SMALL VOX

PROJECT:	SMALL VOX		
DESIGN TITLE:	MODIFICATION OF VOX AD30VT CLONE OF FRIEDMAN SMALL BOX		
AUTHOR:	DRAWING NUMBER	REV:	
Laurent	Drawing_nr	V3C	
DATE:	SIZE:	SHEET:	
03/05/20	A4	1 of 1

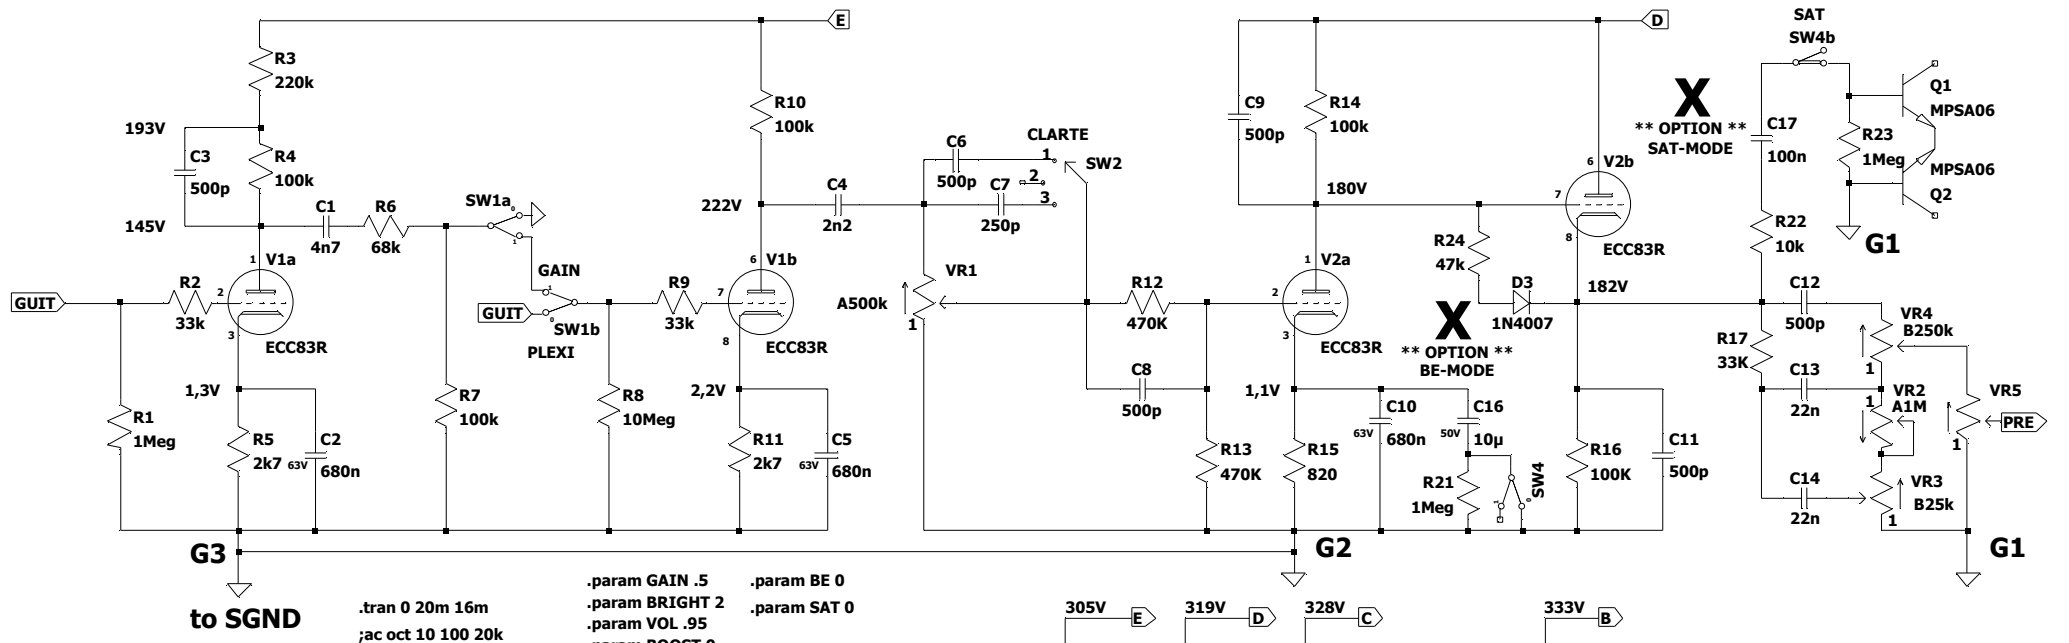
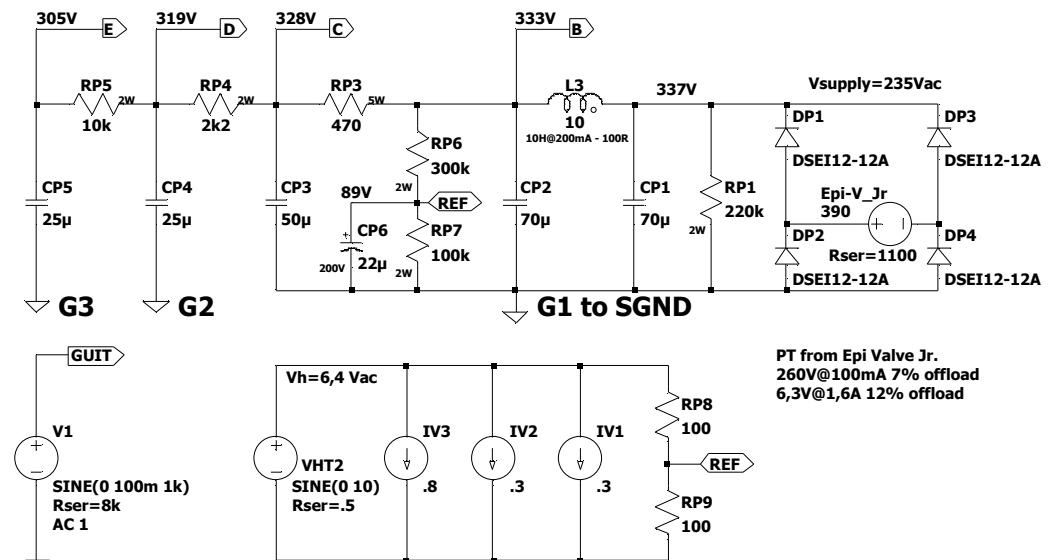
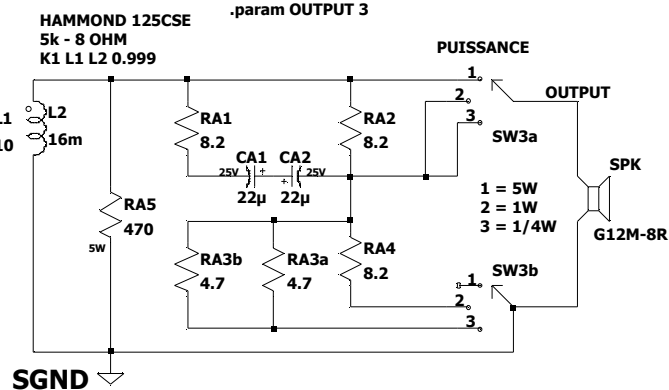
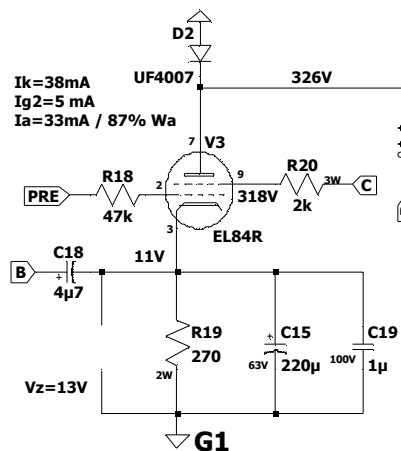
- Input switching optimized
- Updated pin numbering (EL84 at V3!)
- Updated w/ measured voltages
- Ripple feedback rejection at V3 added (C18)
- Added C19
